TOWN OF CANMORE

1. **PL20230327**
1004 3rd Avenue
Lot 2 Block 1 Plan 8410098
Construction of a detached dwelling with an accessory dwelling unit
Variance to water body setback and rear yard setback
Appeal against a refusal by the Canmore Development Authority

STAFF REPORT

DATE OF HEARING:	MARCH 14, 2024
PROPOSED DEVELOPMENT:	SINGLE DETACHED DWELLING (WITH AN ACCESSORY DWELLING UNIT, ATTACHED)
APPLICATION NUMBER:	PL20230327
LEGAL DESCRIPTION:	LOT 2, BLOCK 1, PLAN 8410098
CIVIC ADDRESS:	1004 3 rd AVENUE
CURRENT USE(S):	DETACHED DWELLING
APPLICANT:	ALASDAIR RUSSELL / RUSSELL AND RUSSELL DESIGN STUDIOS

Figure 1: The greatest length of eave projection outside the building envelope can be seen above, with the observed length measured at 0.56m. This is approximately the same distance as the portion of eave seen protruding beyond the eave above, as shown in a portion of the roof plan in Figure 2.

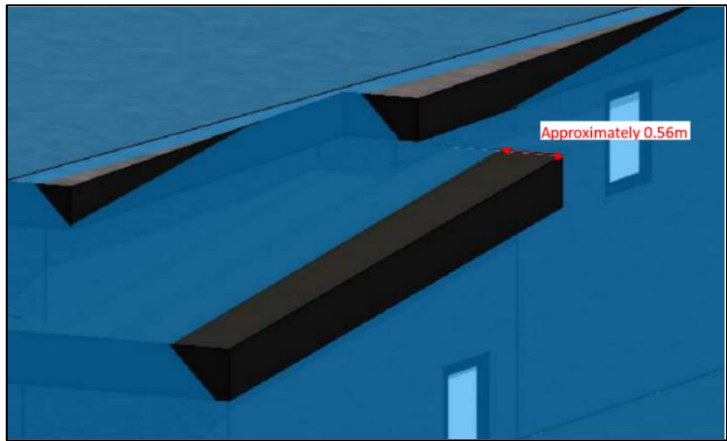
Since the proposed building design contains a multiple-pitch roof, the building envelope model has been used to the maximum building envelope within which the proposed development must be contained, as detailed in section 2.8.4 of the LUB. This creates a three-dimensional maximum envelope, which all of the building must be contained within, except for permitted projections.

Massing Envelope Renderings for the proposed development is included in the design package (see Attachment 4 – Submitted Plans). The renderings highlight each portion of each eave that is proposed to project beyond the maximum building envelope. Each of the eaves included in this variance does not project any further into a yard or waterbody setback than what would otherwise be permitted in Table 2-4-1 of the LUB. The greatest length of eave projecting beyond the building envelope is approximately 0.56m; for reference, the maximum eave projection into any yard setback is 0.61m. See below for a brief discussion of the longest length of eave projecting beyond the building envelope.

The Planning Department supports this variance. The proposed building is under the maximum allowable height, and there are large portions of the maximum envelope that are not being utilized. In addition, these variances are consistent with the built form and character of the streetscape. The eave example noted above is found in the rear of the property, where the impact on adjacent property owners would be minimized. As a result, the proposed envelope variances are acceptable.

Figure 3: Front angle of the eaves projecting beyond the Building Envelope.

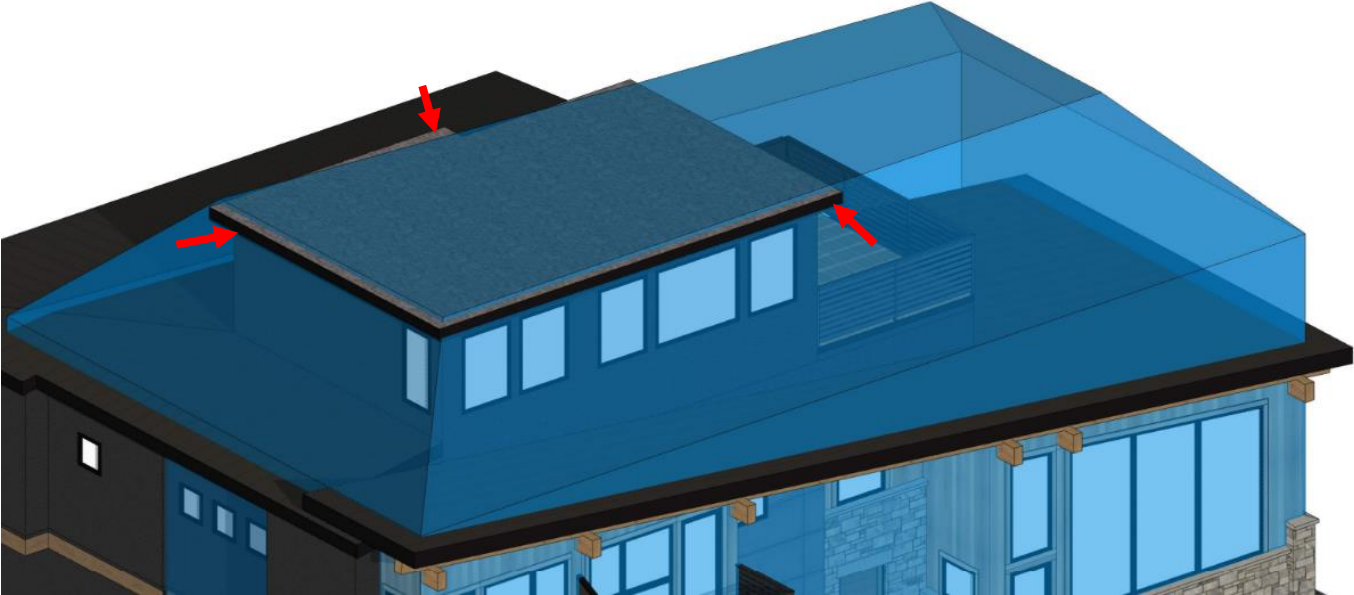
The following pages contain Figures 3 and 4, which provide varying angles of the building envelope, and the subsequent eaves included in this variance request, noted by red arrows.

Figure 5: Highlighted portion of the proposed dwelling, relevant to the Side Yard Setback variance request.

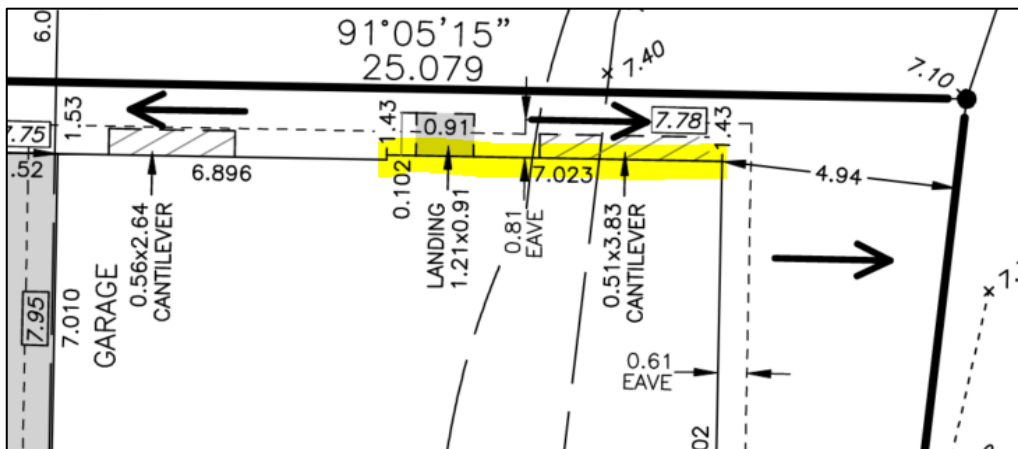
The side yard setback of the existing property currently encroaches 0.07m into the 1.5m side yard (North) setback, as set out in section 3.1.3.6 of the LUB. As this portion of the foundation is proposed to be reused, the new dwelling would continue to encroach 0.07m into the side yard setback. The scope of the variance would be limited to 7.02m of the total length of the house along the North side yard, as indicated in Figure 7.

The Planning Department supports this variance. This variance comes as a result of attempting to reuse the existing foundation, and the Planning Department determined a variance would not increase the extent of non-conformance. The side yard setback could not be adjusted without replacing that portion of the foundation being considered, which would negate some of the benefits outlined above in attempting to accommodate an infill

redevelopment with significant site constraints. This variance would have little impact on adjacent property owners, particularly on the property owner directly adjacent to the north of the requested variance.
